CCK-2617.0-10-24
AG RESEARCH FACILITY 1 – BP 05 TEACHING GREENHOUSE
PROJECT # 2617.0
ADDENDUM # 1
11/13/2024

UK AG Research Building
BID PACKAGE – 05 Teaching Greenhouse
ADDENDUM No. 1
CCK-2617.0-10-25
11/12/2024

Date	November 8, 2024
Project Title	University of Kentucky Agriculture Research Facility 1
To	All Plan Holders
Purpose	Modify the Bid Documents
Distribution	All Plan Holders University of Kentucky Turner Construction A/E Design Team

A RETAINING WALL W/ HANDRAIL
N.T.S.

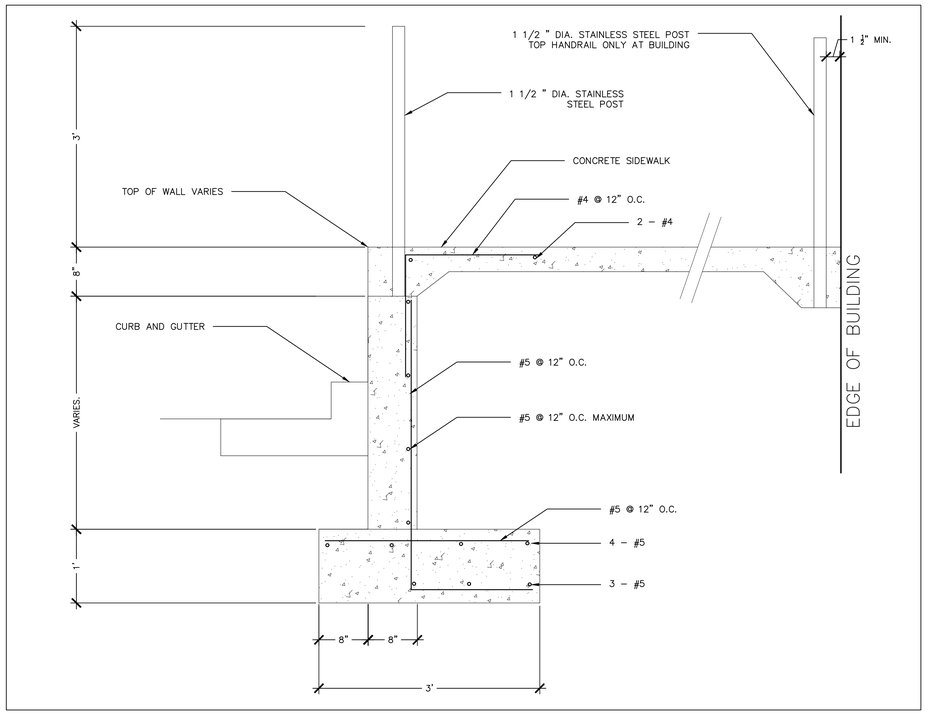
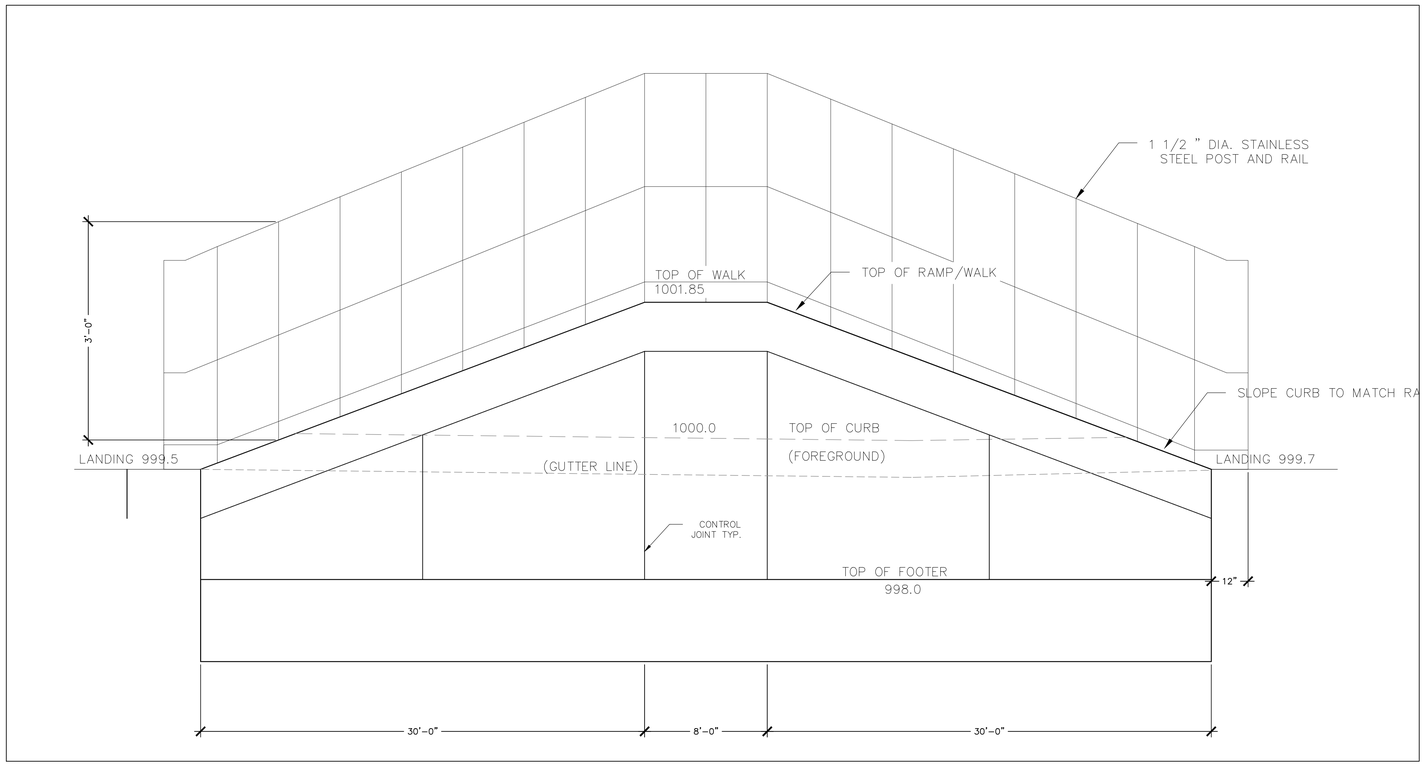
Item 4. Sheet L400.3 – LANDSCAPE DETAILS
- Added detail/dimensions for ramp and handrail.

1 S101.3 T/SLAB = 100'-0" U.N.O.

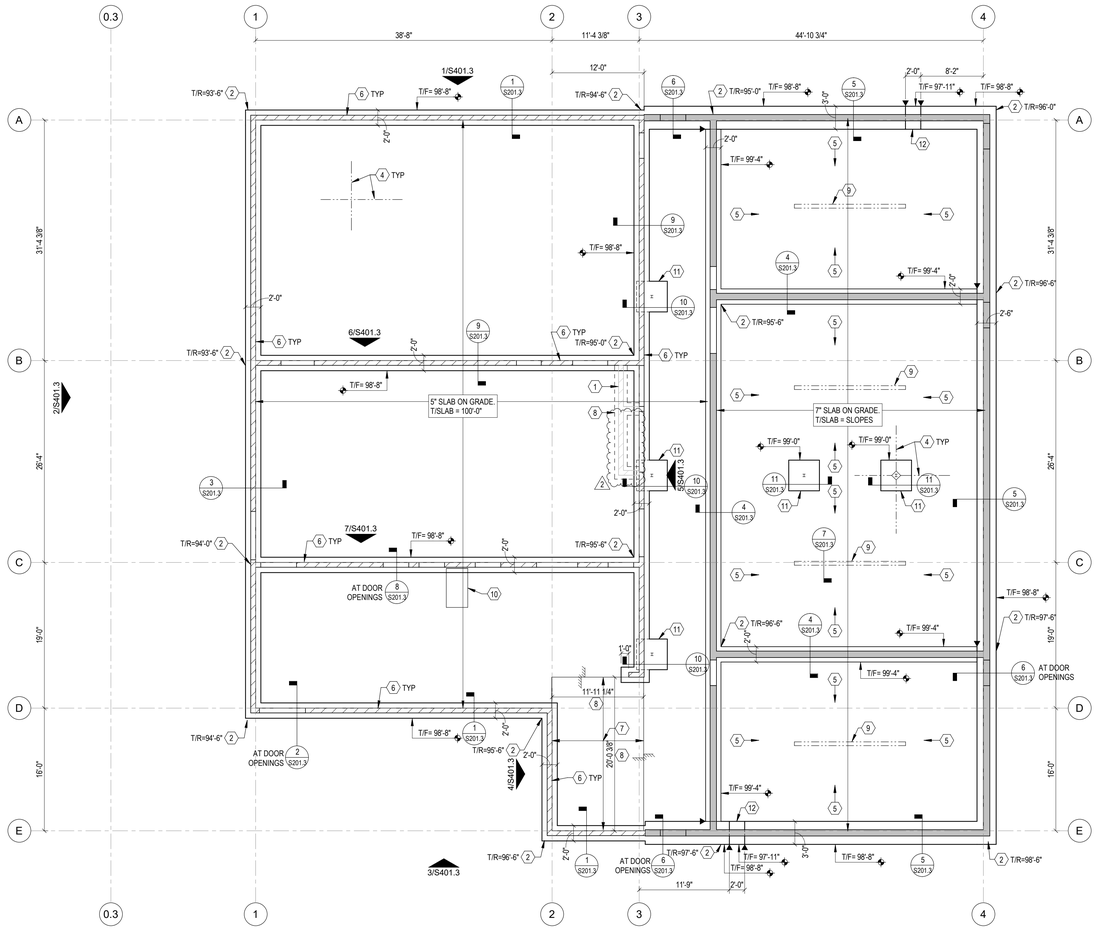
Item 6. Sheet S101.3 - FOUNDATION PLAN
- Added thickened slab under new non-load bearing wall.

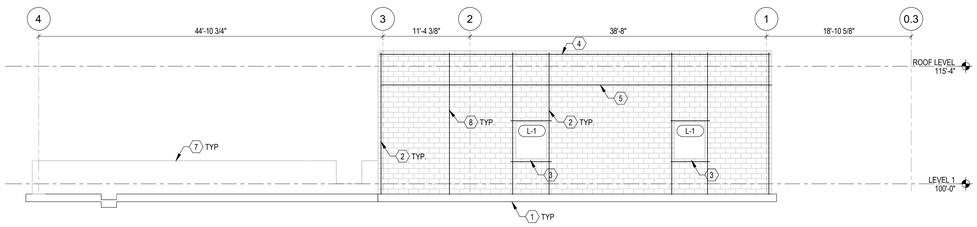
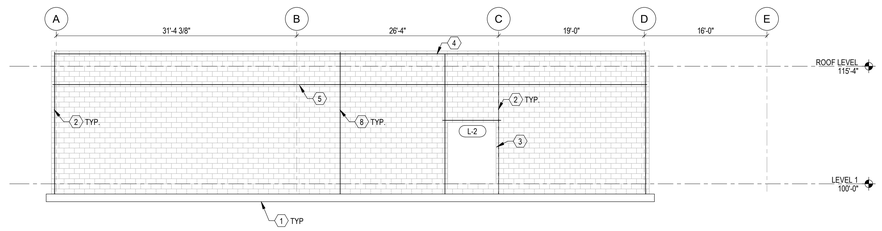
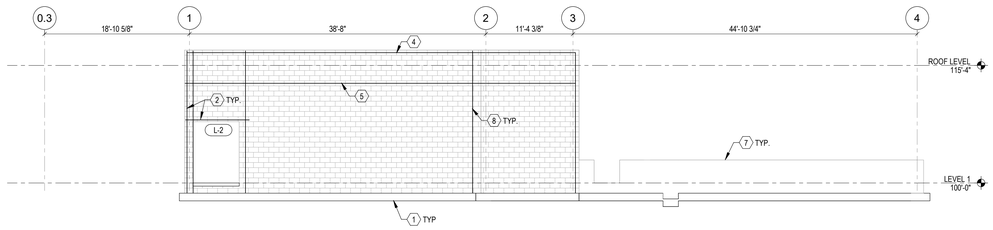
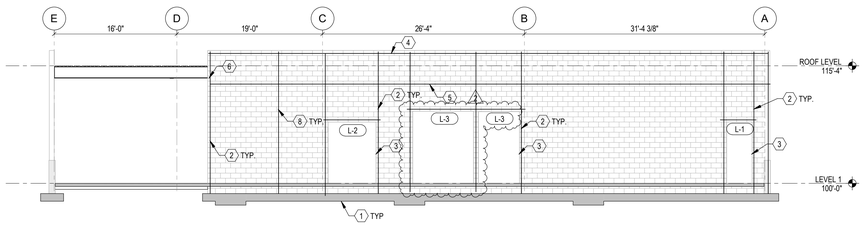
Item 7. Sheet S401.3 – ELEVATIONS
- Added new opening in wall elevation.

A13 / A101.3 — FIRST FLOOR PLAN
1/8" = 1'-0"

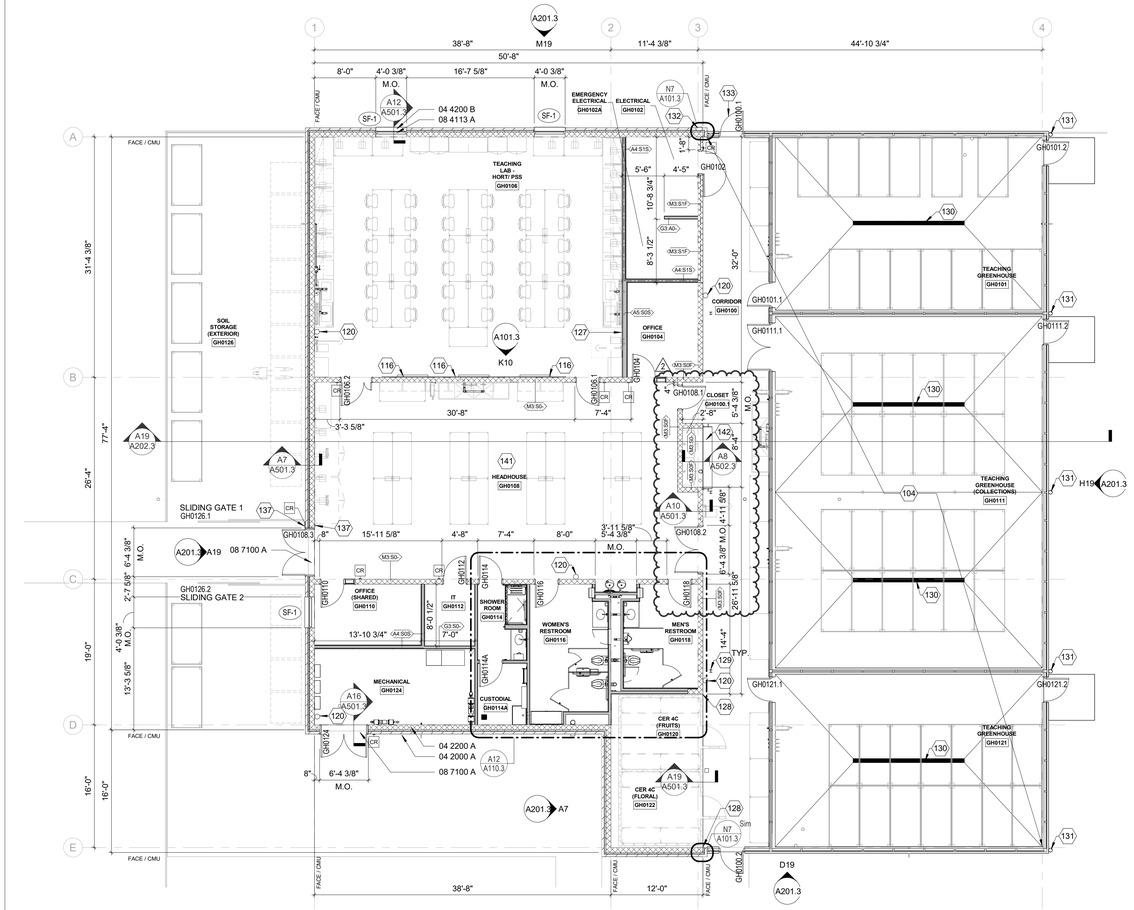
Item 8. Sheet A101.3 – FIRST FLOOR PLAN
- Updated plan to show pesticide cabinet storage Closet GH0100.1, including overhead coiling door.
- Revised dimensions and partition tags.
- Added keynote 142 and added new wall section tag A8/A502.3.

A13 A401.3 REFLECTED CEILING PLAN
1/8" = 1'-0"

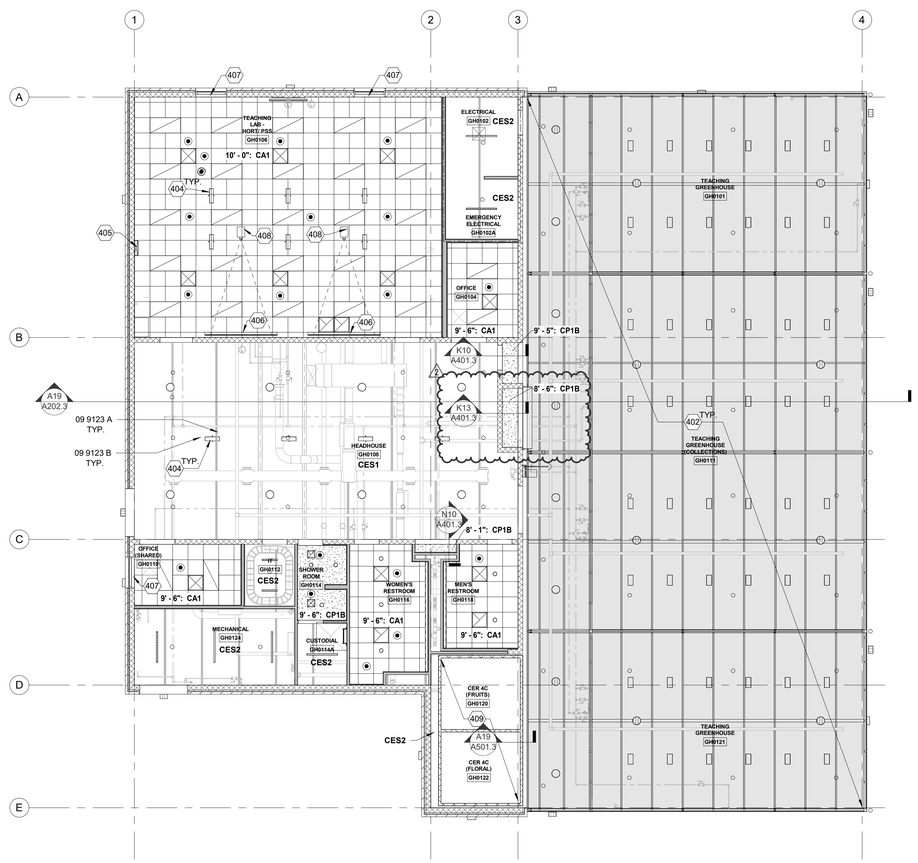
Item 9. Sheet A401.3 – REFLECTED CEILING PLAN AND DETAILS
- Updated plan to show pesticide cabinet storage Closet GH0100.1.
- Added ceiling detail K13/A401.3

A8 A502.3 ROLLING DOOR HEAD SECTION
1/2" = 1'-0"

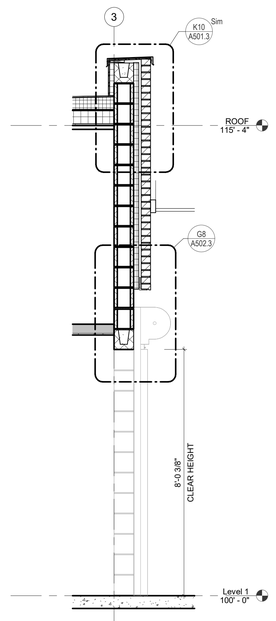
Item 10. Sheet A502.3 – WALL SECTIONS AND DETAILS
- Added sheet for wall section A8/A502.3 and section detail G8/A502.3.

A13 / A801.3 FIRST FLOOR FINISH PLAN
1/8" = 1'-0"

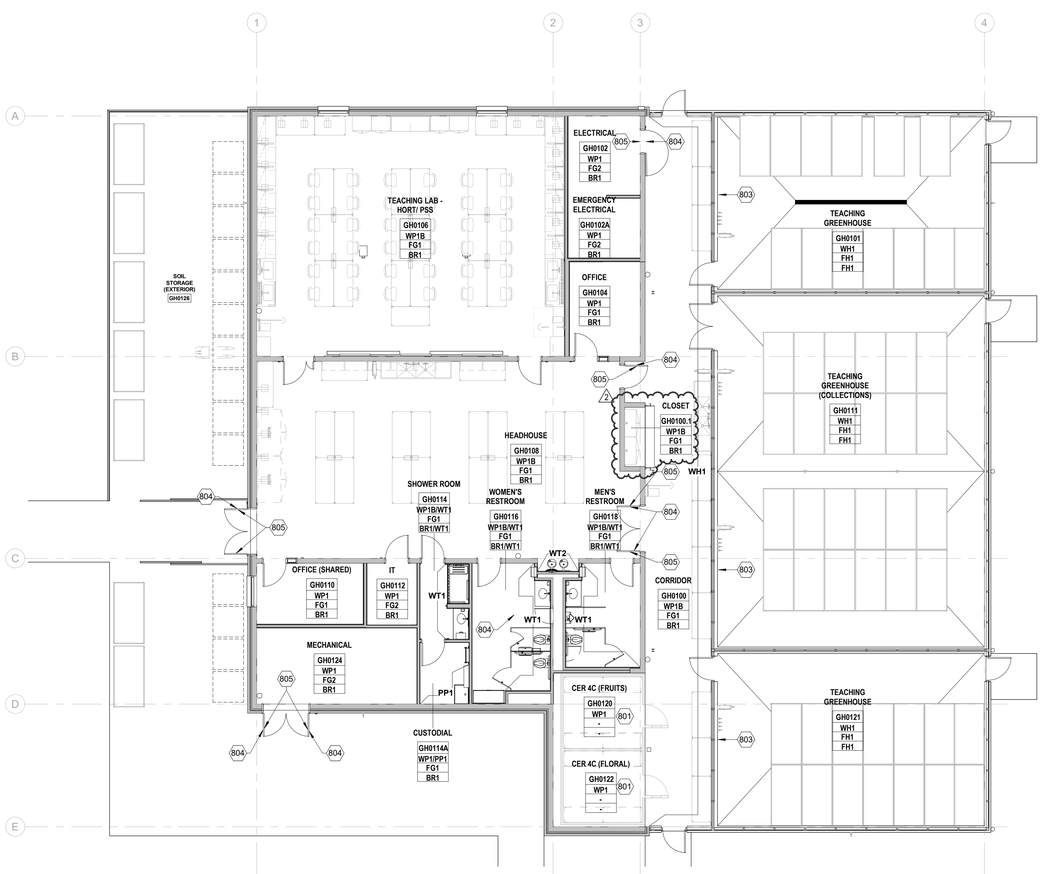
Item 11. Sheet A801.3 - FINISH PLAN AND LEGEND
- Updated plan to show pesticide cabinet storage Closet GH0100.1.
- Added finish tag to Closet GH0100.1

9 Q210.3 GREENHOUSE CORRIDOR ELEVATION - EAST
1/4" = 1'-0"

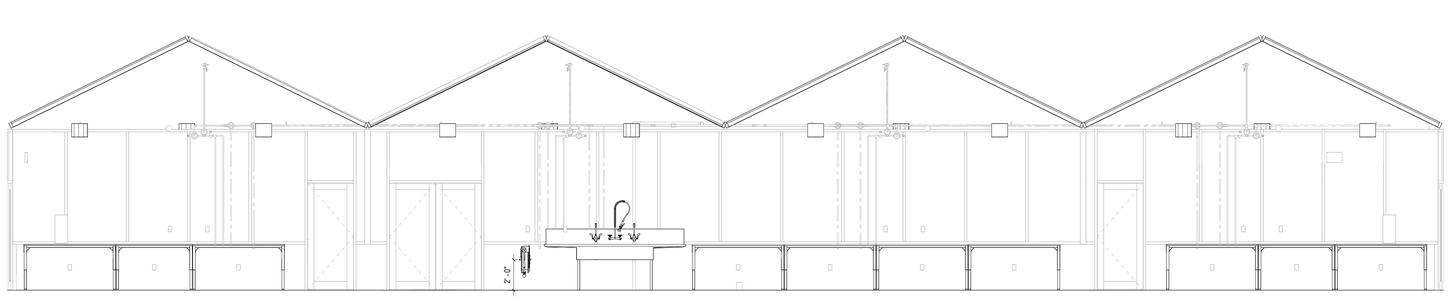
Item 14. Sheet Q210.3 – LABORATORY ELEVATIONS
- Modified Elevations to Reflect Floor Plan Updates.

FIRST FLOOR - PLUMBING

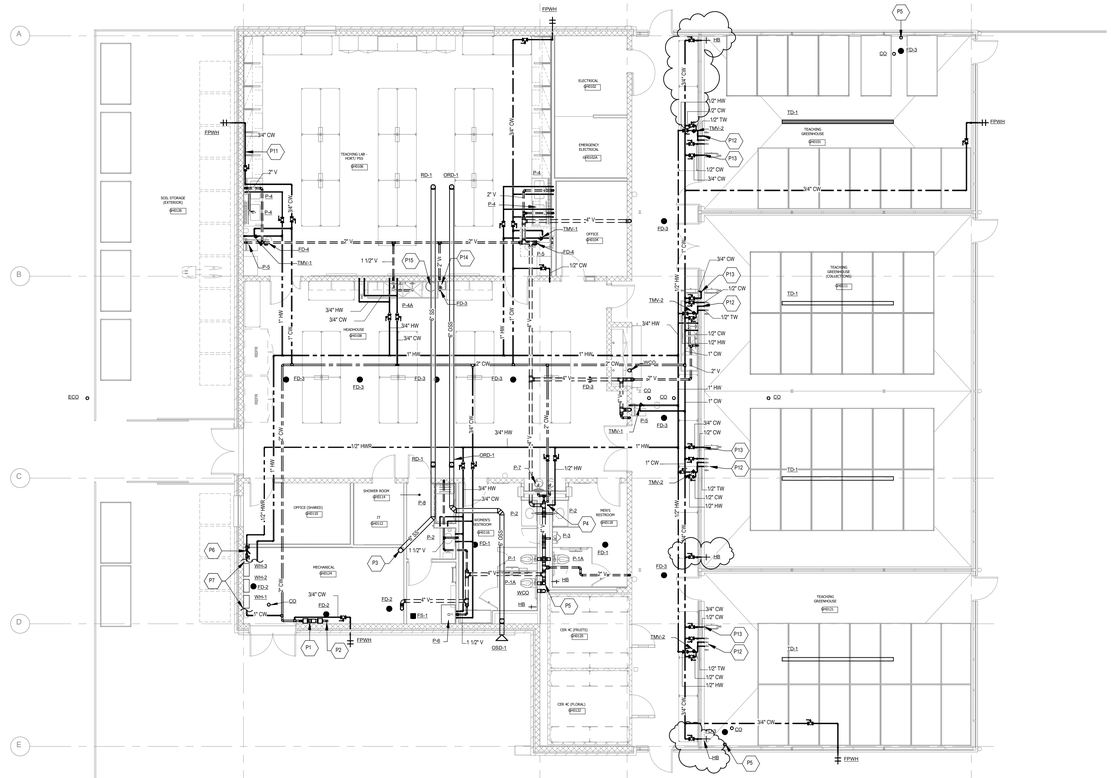
Item 15. Sheet P110.3 – FIRST FLOOR – PLUMBING
- Added hose bibs in greenhouse compartments.

3 ROOF TOP UNIT SECTION

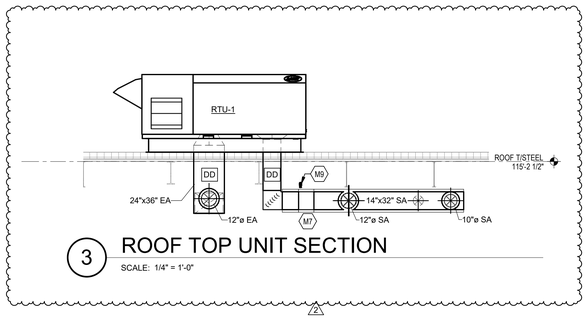
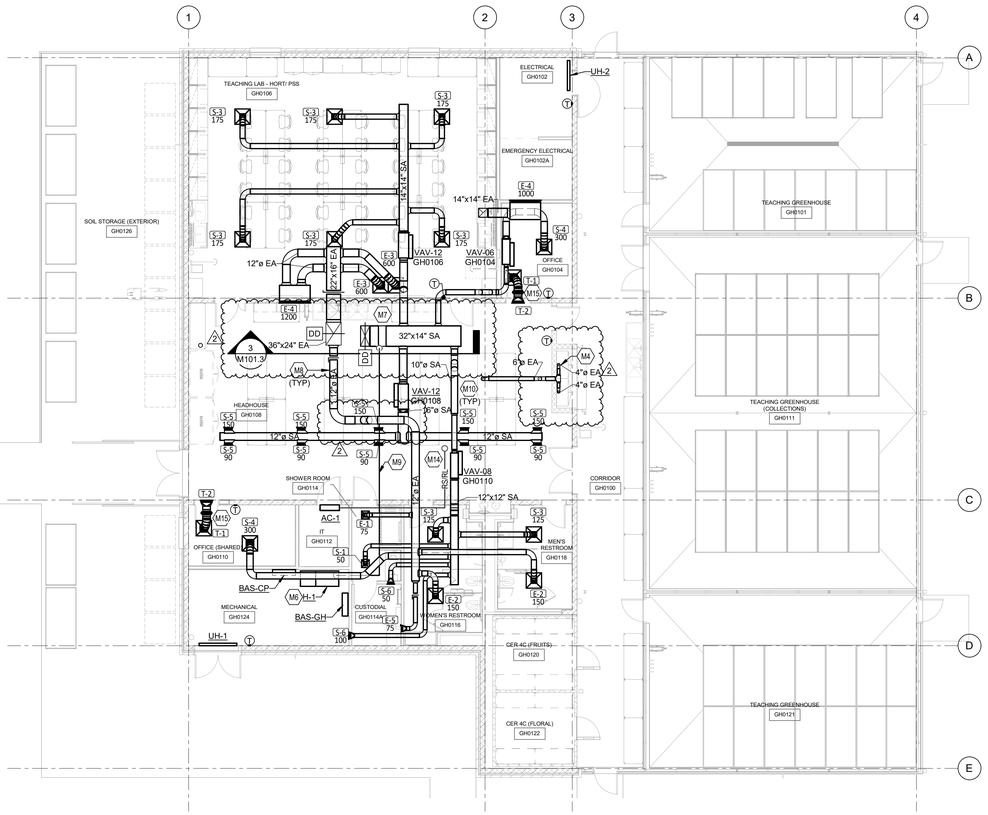
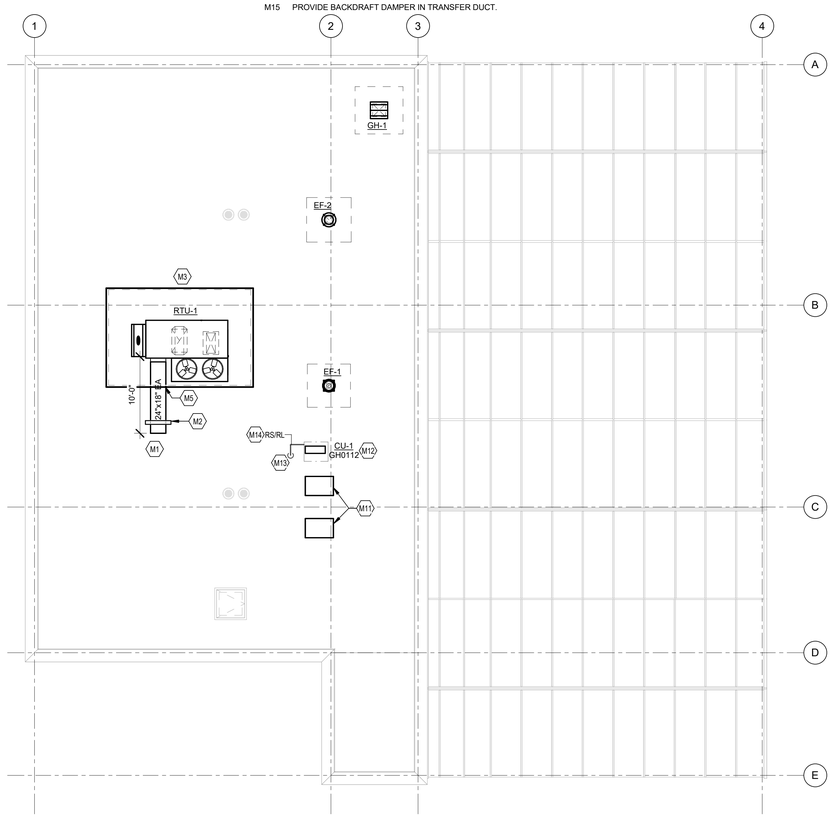
Item 16. Sheet M101.3 – TEACHING GREENHOUSE - MECHANICAL
- Added section view named "ROOF TOP UNIT SECTION".
- Added duct detectors to the inlet and outlet of RTU-1.
- Added an offset to the 12" DIA EA duct to avoid structural beam.
- Shifted the cabinet vent ductwork to coordinate with the new cabinet locations.

TEACHING GREENHOUSE - FIRST FLOOR PLAN - POWER

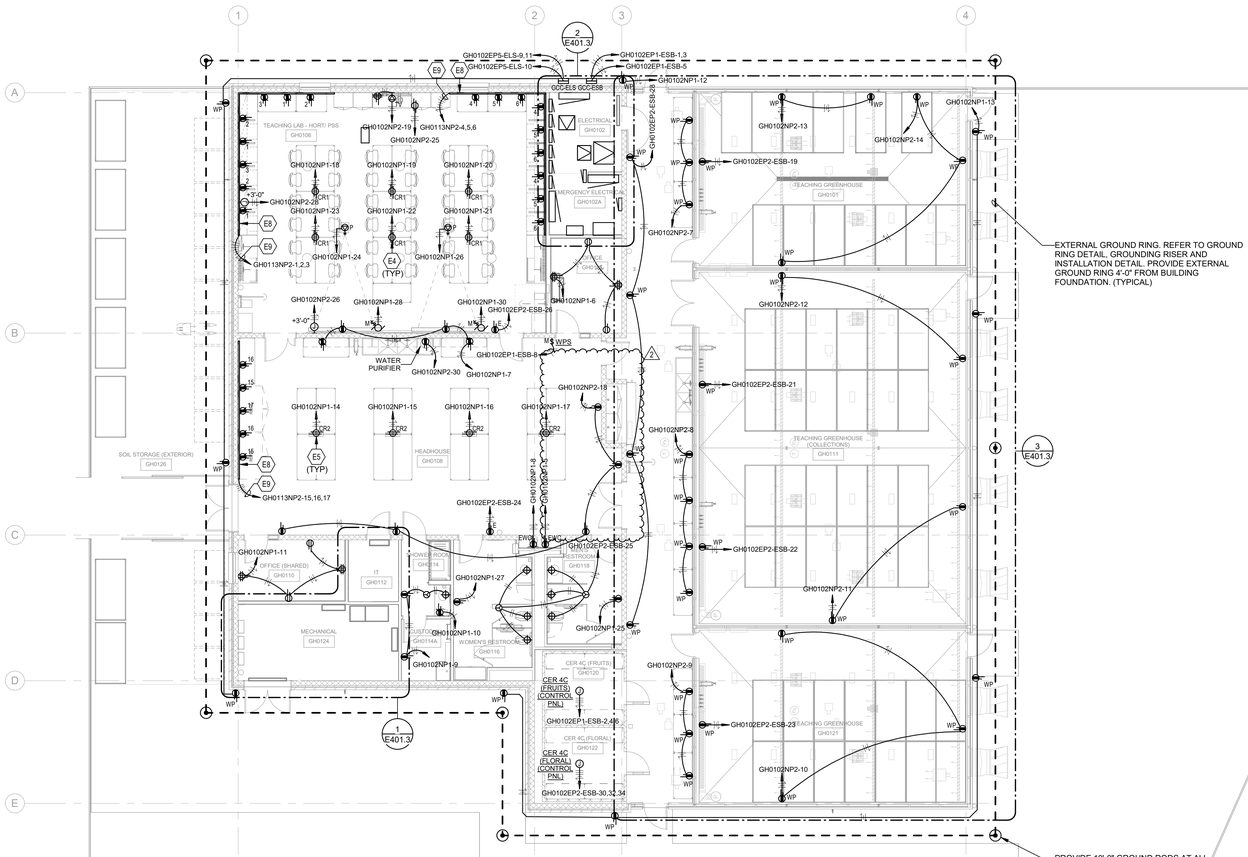
Item 17. Sheet E201.3 – TEACHING GREENHOUSE – FIRST FLOOR PLAN – POWER
- Revised Headhouse GH0108 to remove wiremold on plan east wall.
- Added two (2) receptacles to plan east wall.
